## 6C Containment Debris Protection for ECCS Strainers

STD DEP 6C-1 (Figure 6C-1, 6C-2, 6C-3, 6C-4, 6C-5)

STD DEP Vendor

Figure 6C-1 Cassette Strainer Cutaway

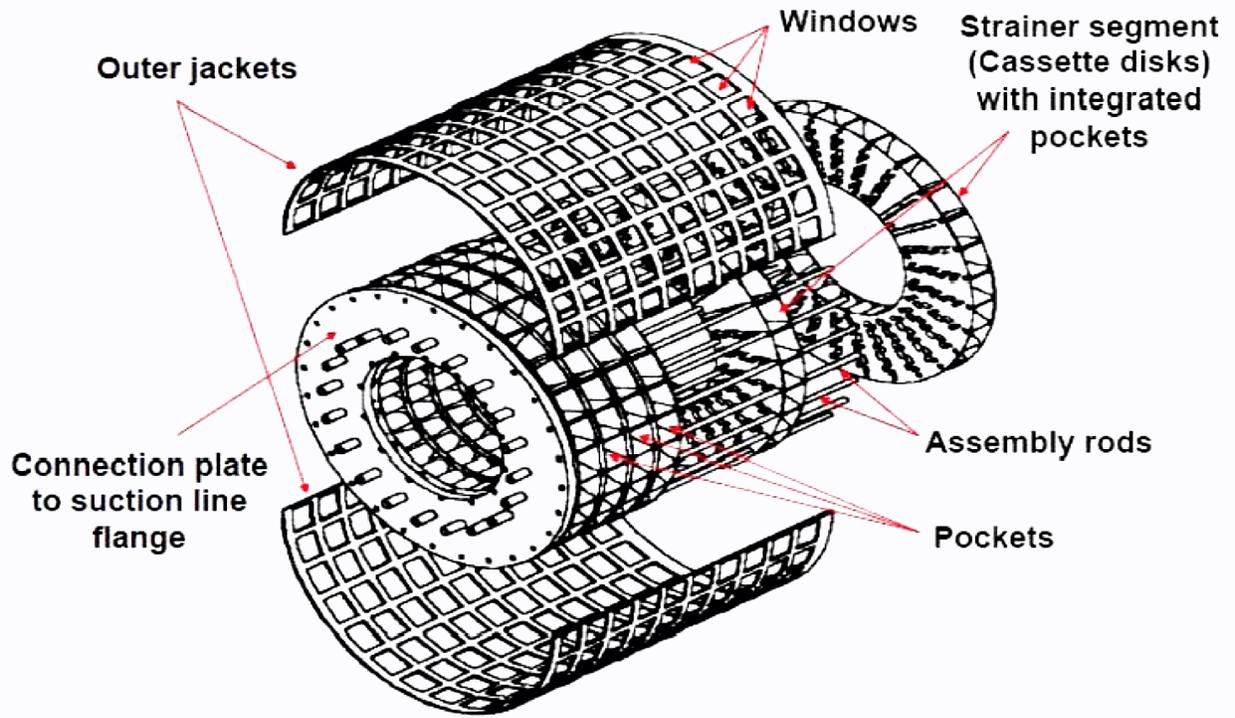
The suction strainers design at Perry preceded and did not meet the current regulatory requirements. The ABWR ECCS suction strainers will utilize a "T" arrangement with conical strainers on the 2 free legs of the "T" a cassette type strainer design. This design separates the strainers so that it minimizes the potential for a contiguous mass to block the flow to an ECCS pump. The design of the strainers will be based on Regulatory Guide 1.82, NUREG/CR-6224 (Reference 6C-4), NUREG/CR-6808 (Reference 6C-5) and the Utility Resolution Guidance, NEDO-32686-A. The cassette type strainer design is based on a set of cassette modules with U-shaped filter pockets attached to the cylindrical outer jacket. Each strainer consists of filter modules, the outer jacket and flange plates on each end of the cylindrical assembly. The filter module is constructed with cassettes which are arranged axially along the strainer axis. One cassette consists of pocket shaped filters which are arranged radially. A cut-away drawing of the strainer is shown in Figure 6C-1. The material used in the cassette type strainer is stainless steel. The cylindrical strainer assemblies are mounted in pairs on piping tees at each ECCS pump suction line. When the ECCS pump operates, the suction flow in the suppression pool runs into all pockets through the outer jacket windows. Each pocket has five flow paths from the inlet through the five perforated walls to the outlet of the pocket towards the cassette strainer. By using the cassettes with the pocket shaped filters, the strainer has an available filter area which is larger per volume than cylindrical and other shaped strainers. The number of cassettes and pockets is adjusted to produce a specific head loss performance for the strainer. To avoid debris clogging the flow restrictions downstream of the strainers, the size of the holes in the perforated sheets is chosen by considering specific paths of ECCS equipment and piping (for example, the containment spray nozzle and the ECCS pump seal cooling flow orifices). The STP 3 & 4 strainers will have holes no larger than 2.1 mm.

Figure 6C-2 Core Inlet Delta-P for Blocked and Unblocked Cases

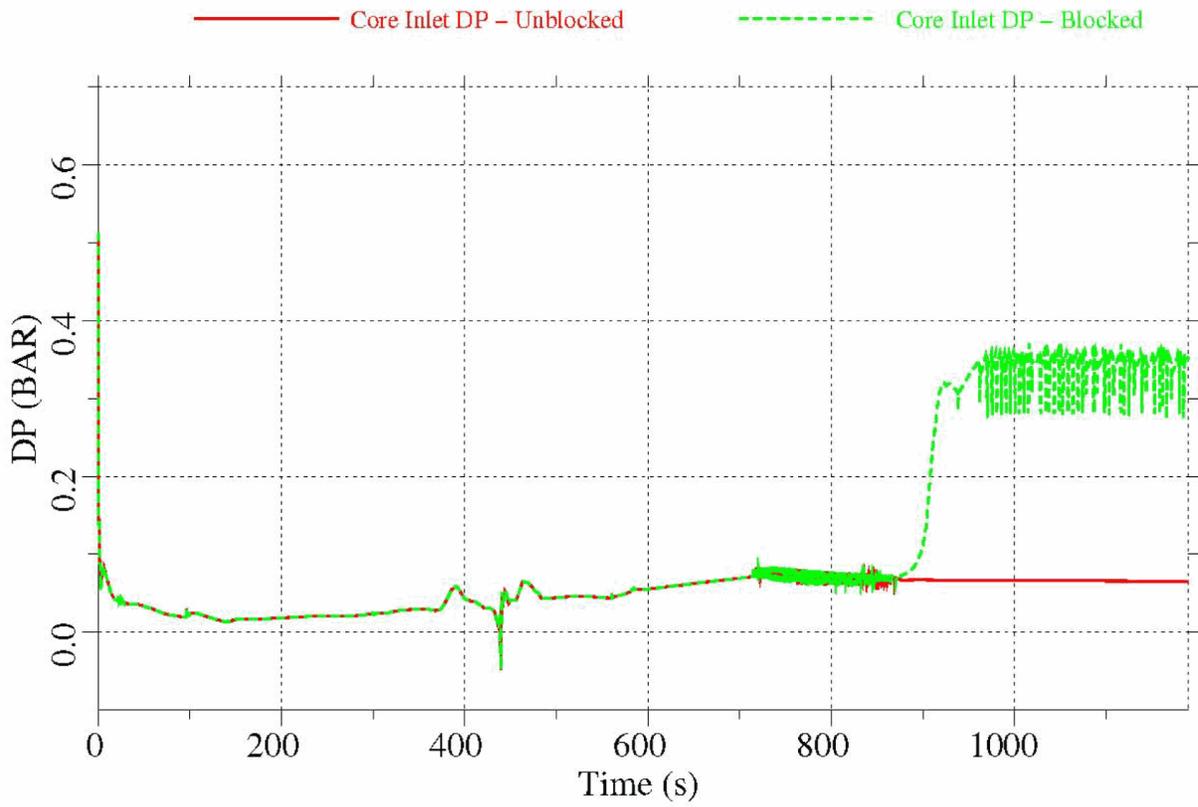
Figures 6C-2, 6C-3, and 6C-4 compare the core inlet DP, flow rate and void fractions for the cases with no blockage and with blockage resulting in a reduction of flow area by 90% of inlet flow area. Five minutes is the estimated amount of time required for debris in the containment to start to reach the fuel filters. The models assume clogging begins at 850 seconds because that is when the flow through the core reaches steady state. In order to ensure any effects seen are covered by the changes being made, steady state flow is required. Despite a very high level of blockage, sufficient flow remains available to the core to ensure that the core void fraction both in the hot assembly and average assembly remain  $< 0.95$ .

The results of the analysis provide an acceptable core inlet differential pressure (DP), corrected for the flow rates to account for the fact that the flow rate will decrease differently in the test loop (supplied by a pump) vs. in the analysis (controlled by natural circulation head).

Figure 6C-5 Peak Clad Temperature for Blocked and Unblocked Cases

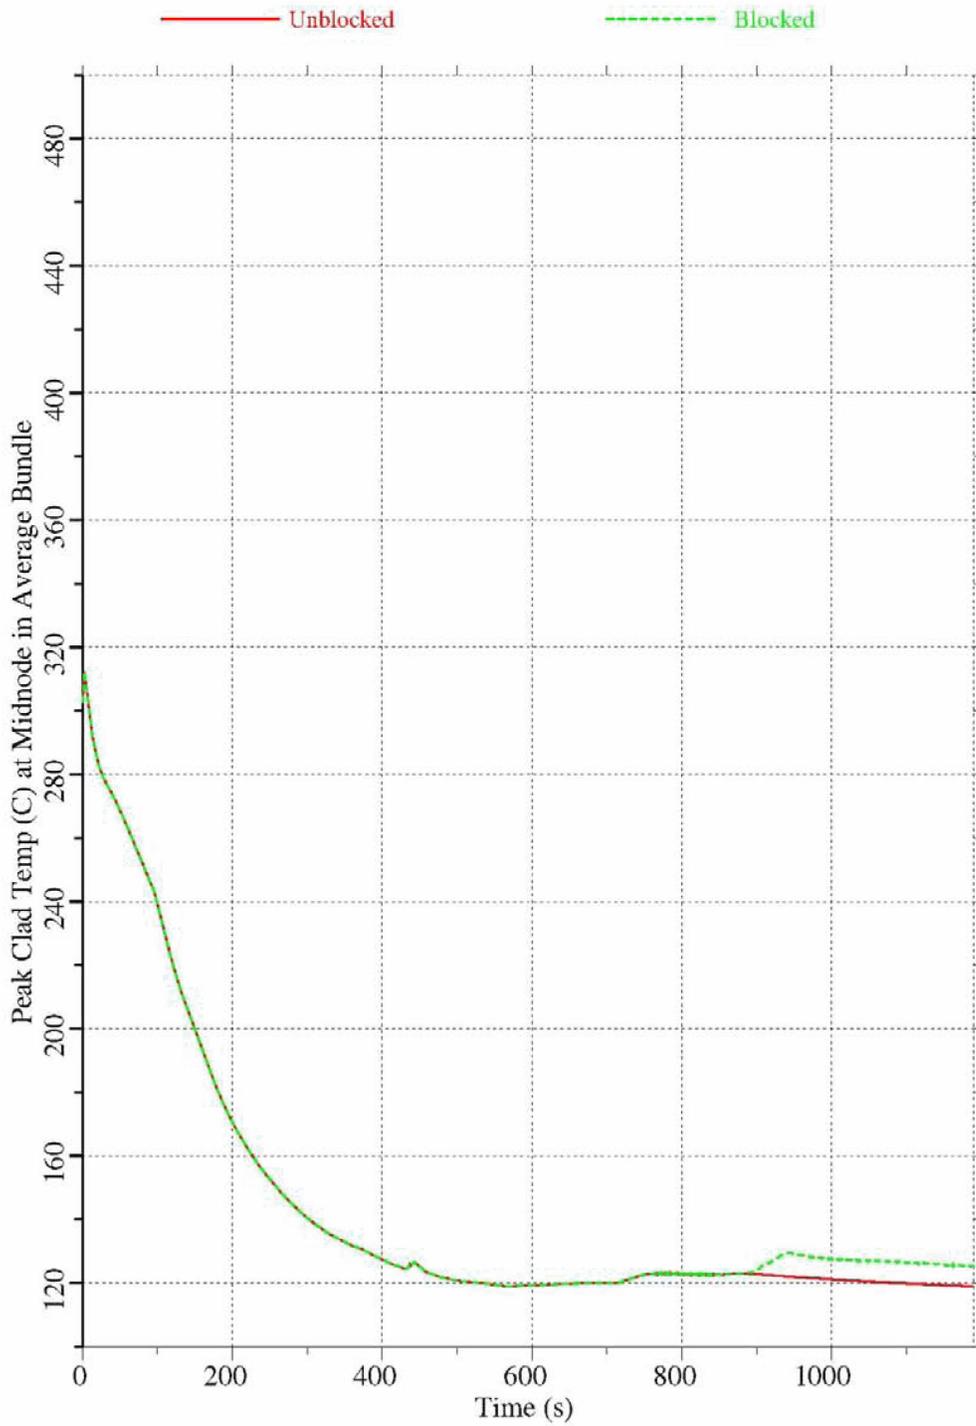
In the ABWR design, the peak cladding temperature (PCT) occurs very early in the transient during the Reactor Internal Pumps (RIPs) coastdown phase, before ECCS injection occurs. Therefore, the PCT remains unaffected during the RIP coastdown by the subsequent blockage at the fuel inlet because the cladding temperature is maintained low (near the saturation temperature) as the core void fraction, both in the hot and average assemblies, is maintained below  $< 0.95$ . Figure 6C-4 provides a comparison of cladding temperature for the blocked and unblocked cases. The low fuel clad temperature also ensures that cladding oxidation does not occur in the long term cooling phase of the accident.

The impact on the clad temperature of fouling caused by an assumed deposition of particulate debris on the cladding is small. The increase in PCT from low fouling to high fouling is only approximately 30 deg F.
